ADDENDUM No. 1

RFP No. 25-53

LIBERTY STREET CREEK RESTORATION

Figure 1: Low/Moderate Kinetic Energy Erosion Control Blanket Installation

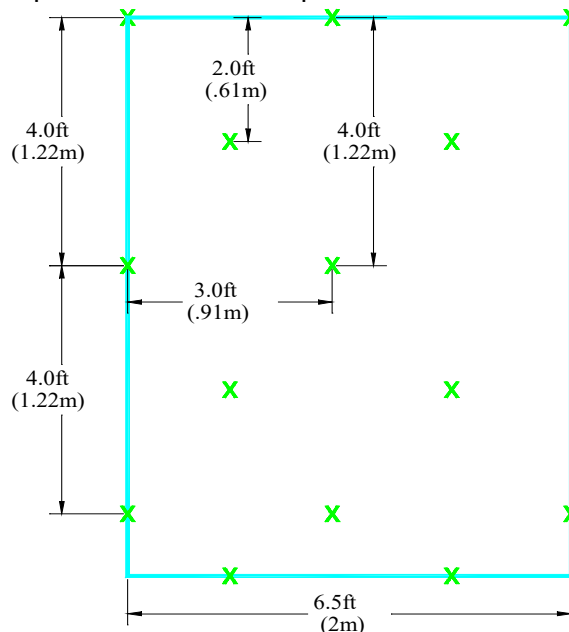
Question 13: Is there a specification for erosion control blanket and stapling pattern?

Answer 13: The staple pattern is to be used for the installation of a low-to-moderate kinetic energy area. Please see the diagram below. Follow installation instructions per Article 12, SD-SESC-4, or per manufacturer's specifications.

STAPLE PATTERN "C"

1.75 staples/yd² (2.1 staples/m²) using 6 in (15.2 cm), 11 ga. wire "U" staples. 8 in (20.3 cm) staples and longer may be used for loose soils. 9 ga. staples or heavier may be necessary in hard or rocky soils.

SESC PLAN

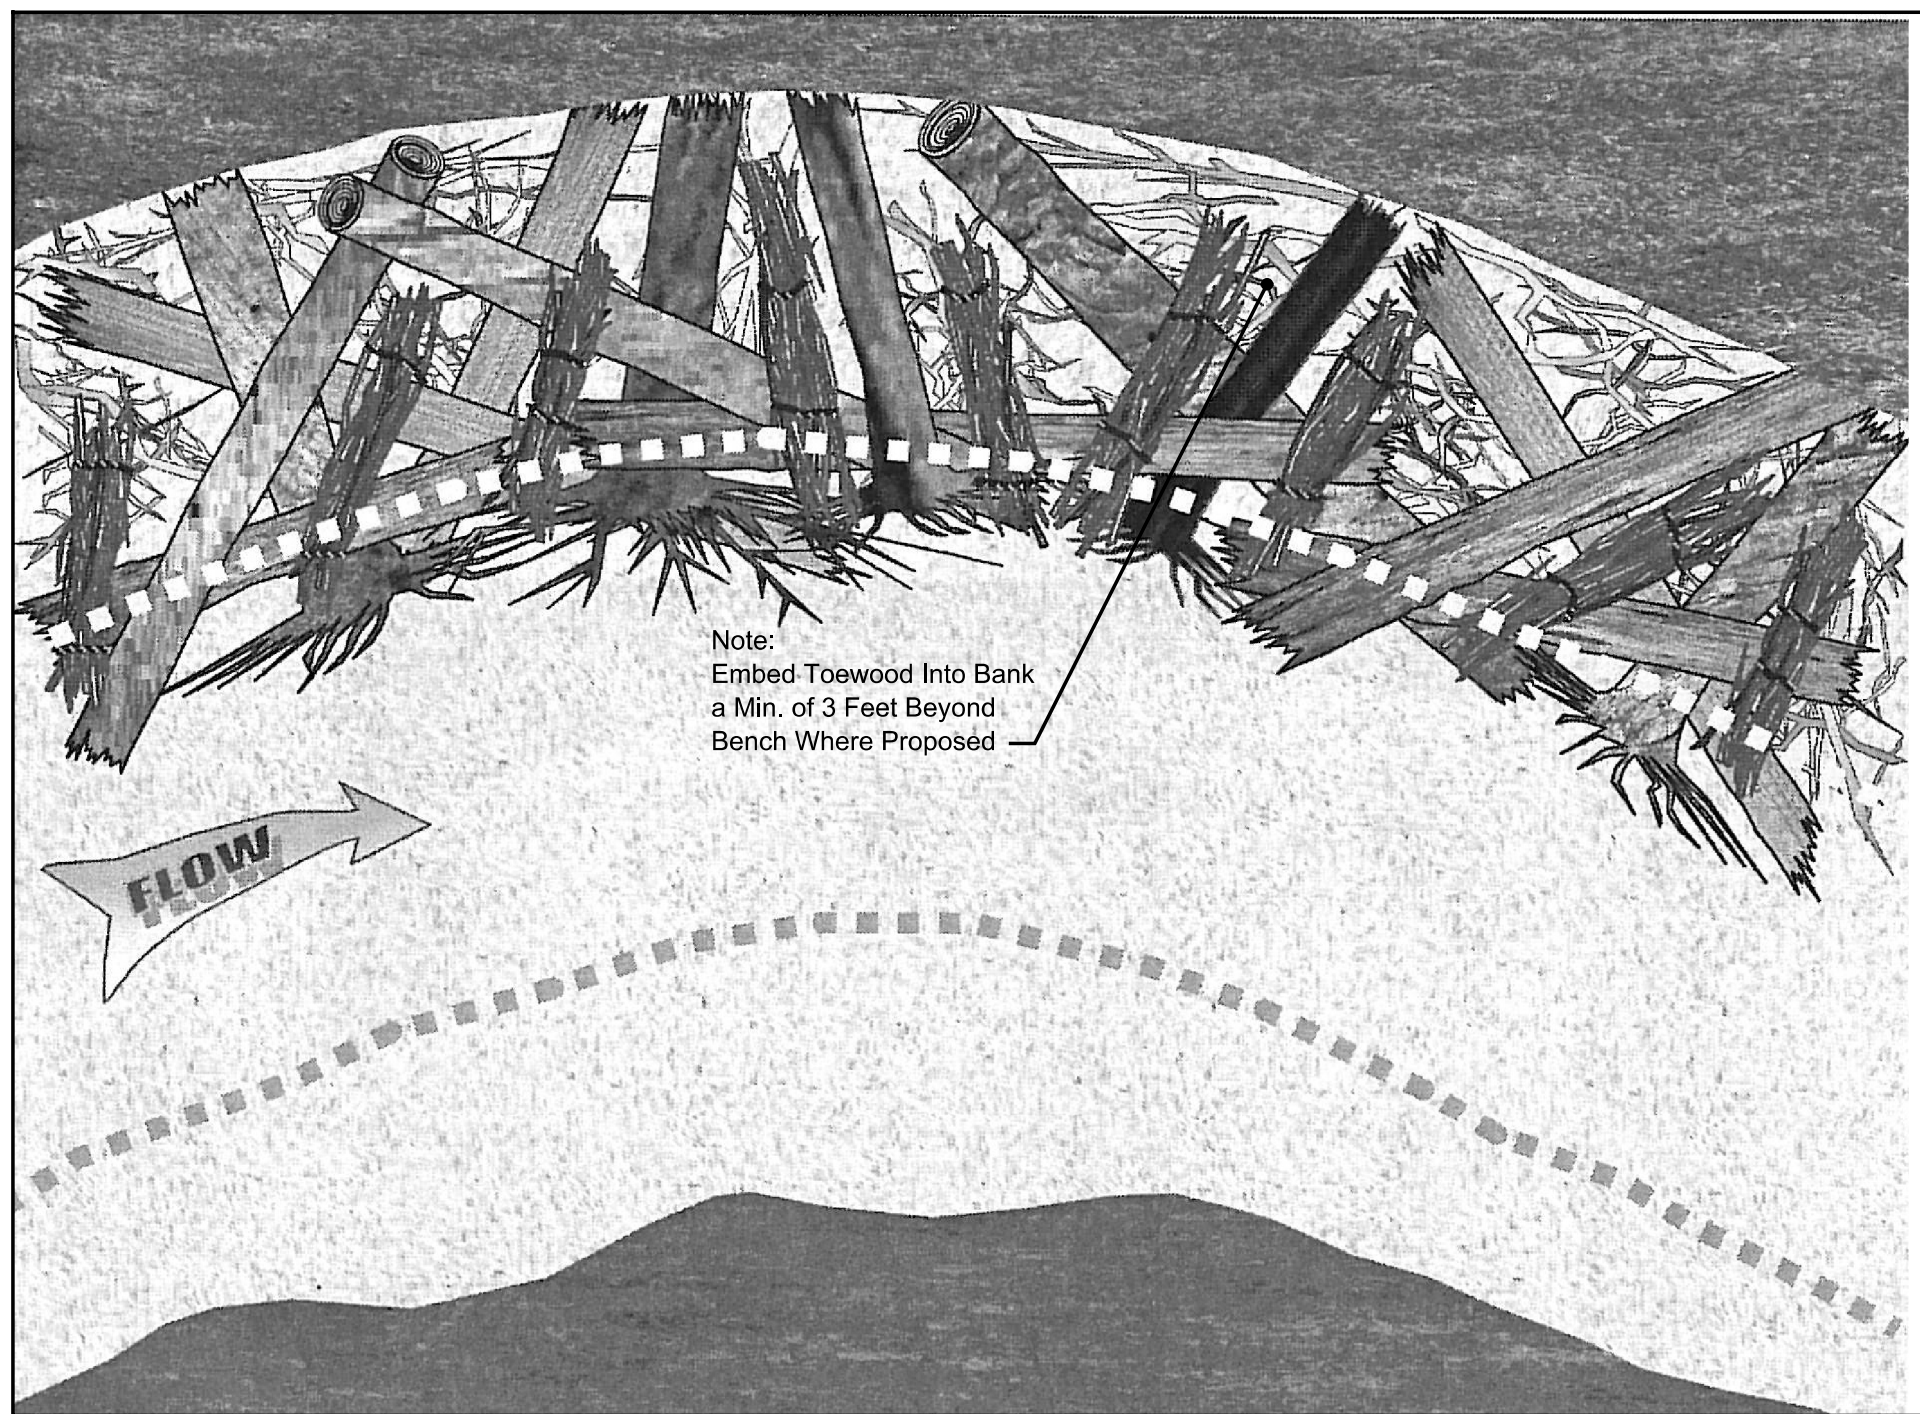
Sheet 03 – SESC Plan:

Revised access routes to reflect revised staging and laydown area

TOE WOOD PLAN

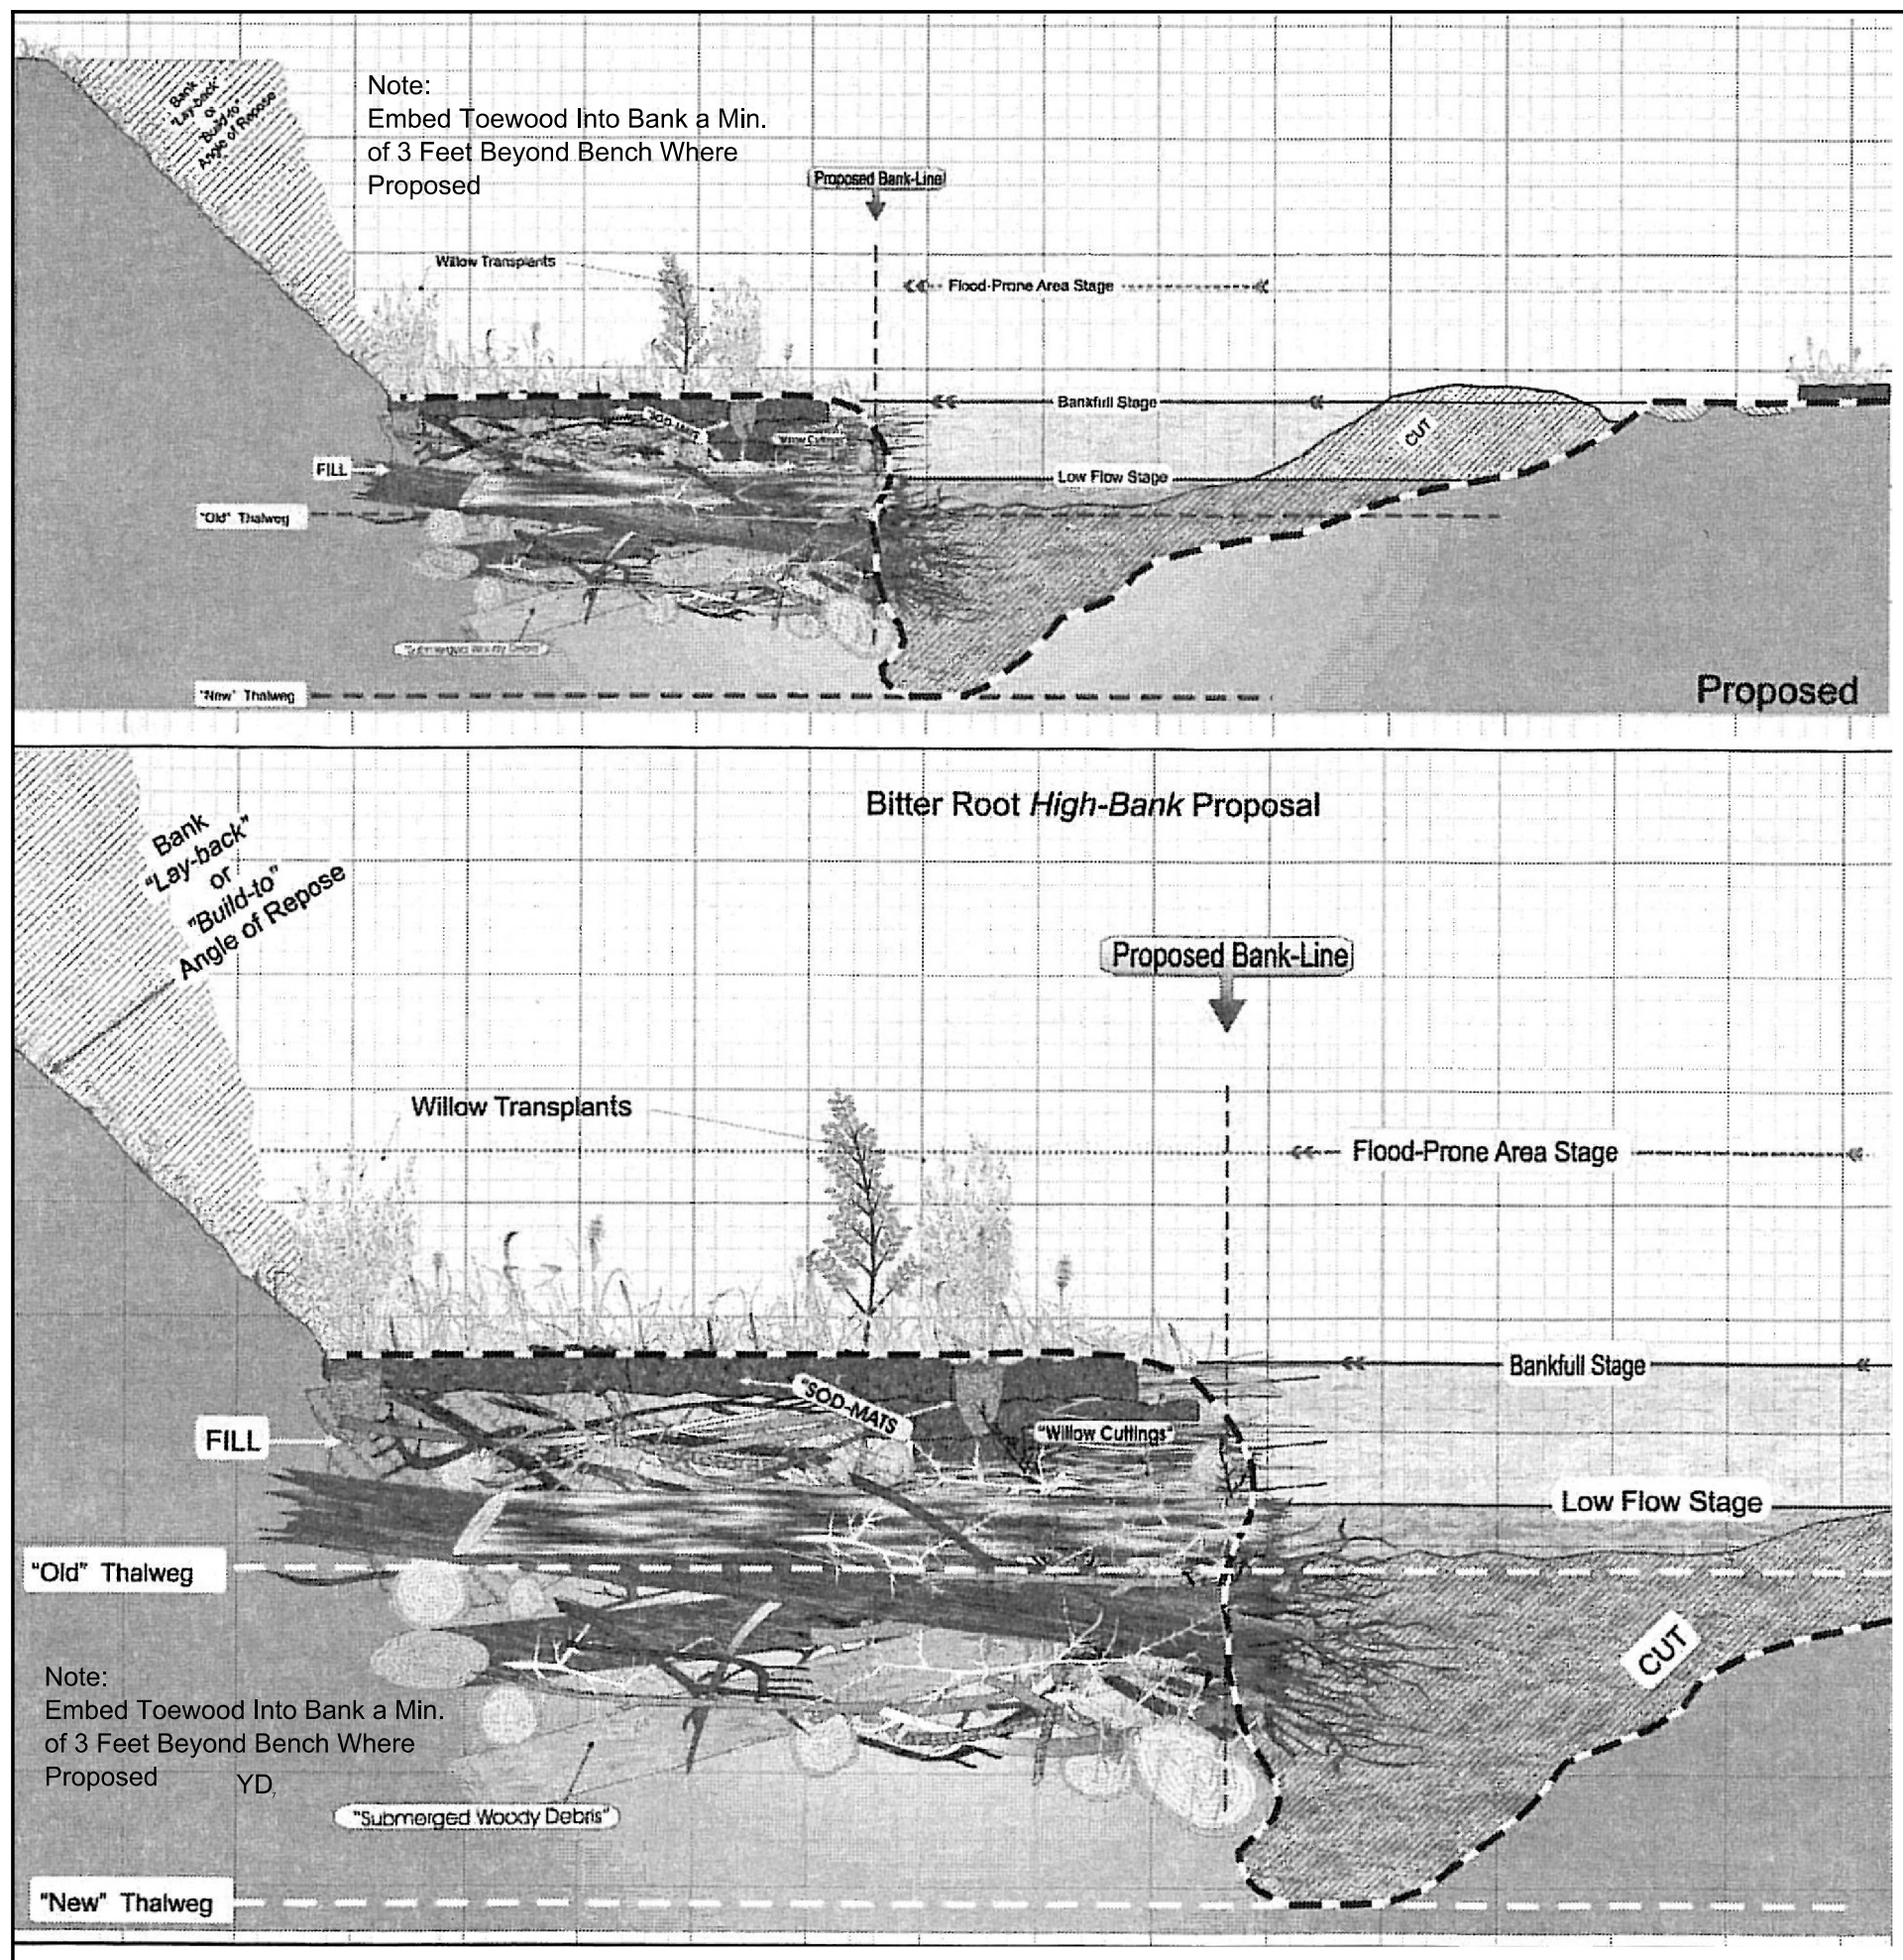
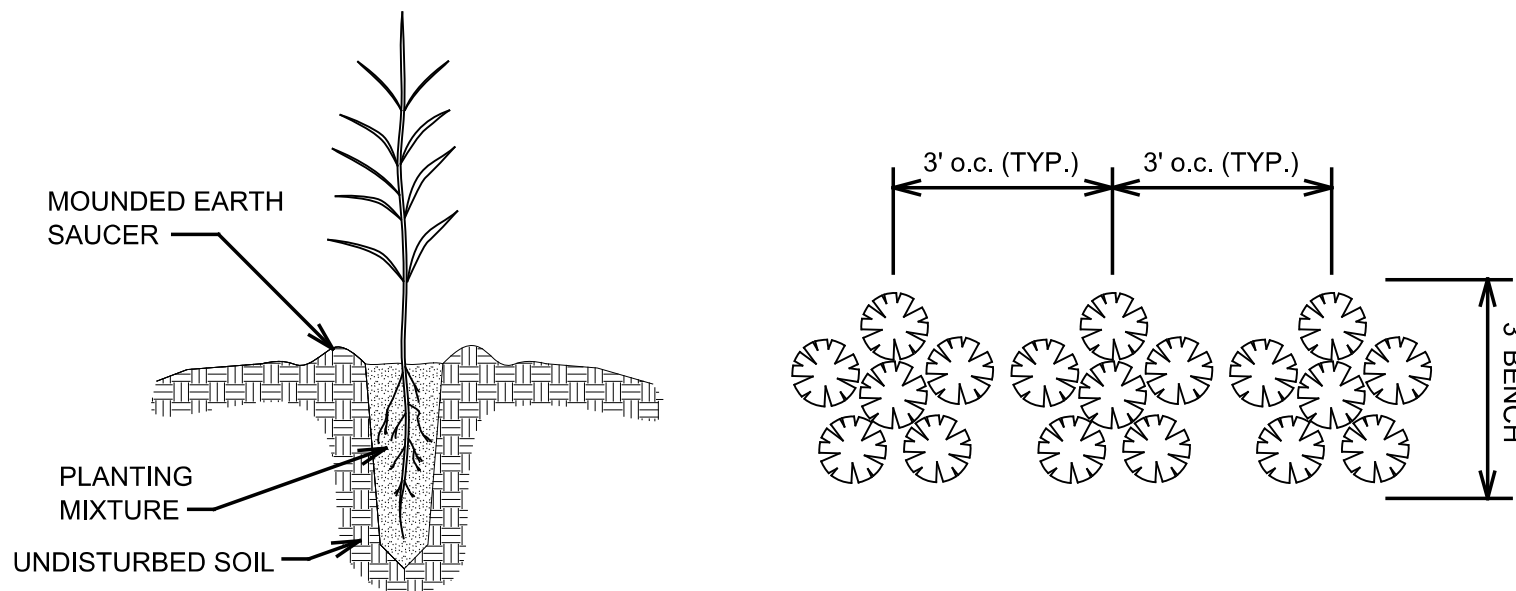
Question 8: Is there a clear detail for the live branch layering/live staking, when looking at the toewood section provided on Sheet it is difficult to see where the willow cuttings are going if those are the live stakes?

Answer 8: No live stakes shall be used for this project, as noted in Answer 7. The sections shown on Sheet 19 are for graphic purposes only. See the Toe Wood General Notes on Sheet 19 for construction sequence of the Toe Wood structure.

PLANT PLUG
NO SCALE

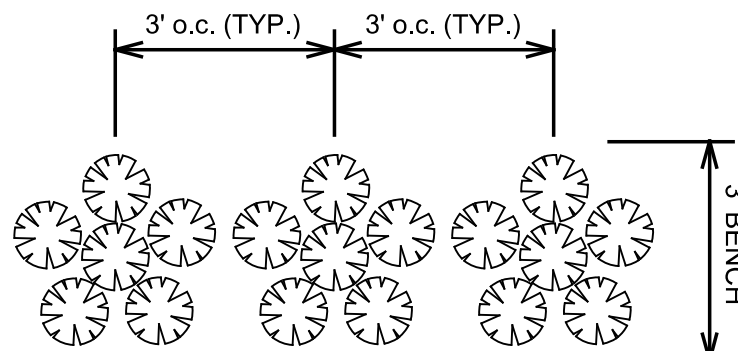
Sheet 19 – Project Details:

Revised Note 1 for the Plant Plug Detail

Question 6: Detail for Plant plug notes have the plugs to be planted at 3ft o.c., but diagram looks to show that the clusters of 5-9 plants are planted on 3 ft o.c.? Or specification for Native plant plugs reads to space plugs on 24-in centers in staggered pattern?

Answer 6: Place plant plugs in clusters of 5-9 plants 3 ft O.C. according to diagram and detail. The wording found in the Native Plant Plug specification has been updated.
